Sundry ID: 2695893

HILCORP ENERGY COMPANY
Valencia Canyon Unit 13
NOTICE OF INTENT TO PERMANENTLY ABANDON

Well: Valencia Canyon 13

BLM FLUID MINERALS P&A Geologic Report

Valencia Canyon Unit 13 - PROPOSED P&A SCHEMATIC

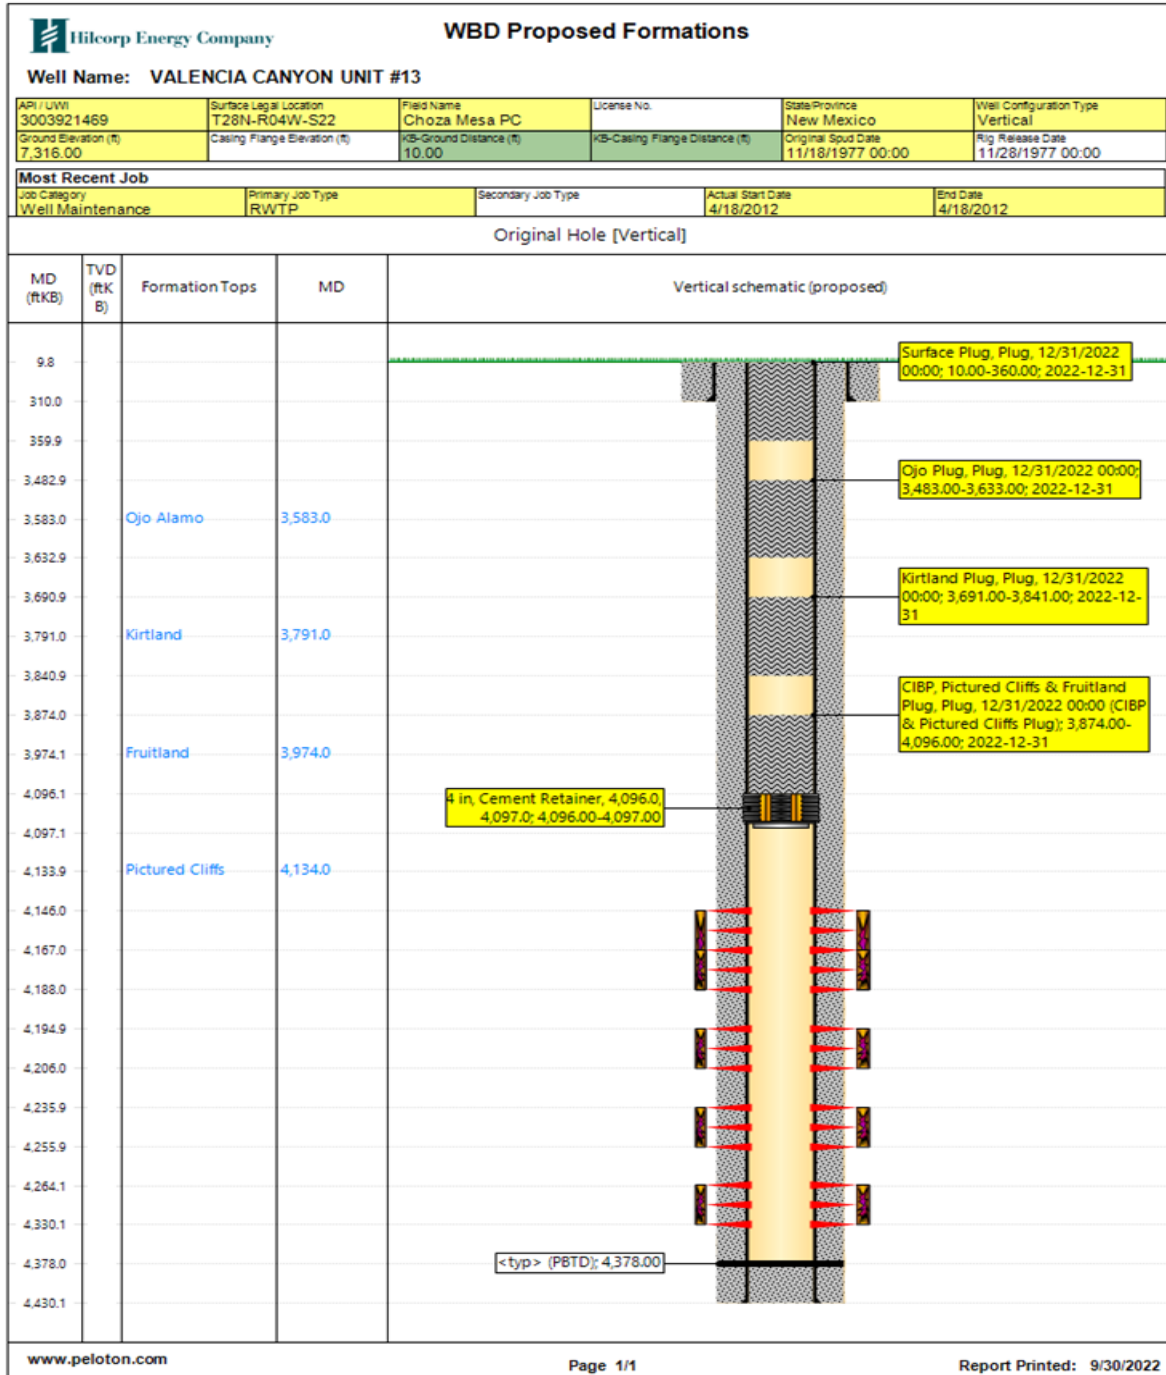
1. Plugging operations authorized are subject to the attached "General Requirements for Permanent Abandonment of Wells on Federal and Indian Lease."
2. The following modifications to your plugging program are to be made:
 - a. Combine Plug #2 (Kirtland) and Plug #3 (Ojo Alamo) to cover the entire Ojo Alamo formation.
 - b. Add a plug to cover the Nacimiento formation top at 2200'.
3. Farmington Office is to be notified at least 24 hours before the plugging operations commence at (505) 564-7750.

- Combine Plug #2 (Kirtland) and Plug #3 (Ojo Alamo) to cover the entire Ojo Alamo formation.

- Add a plug to cover the Nacimiento formation top at 2200'.
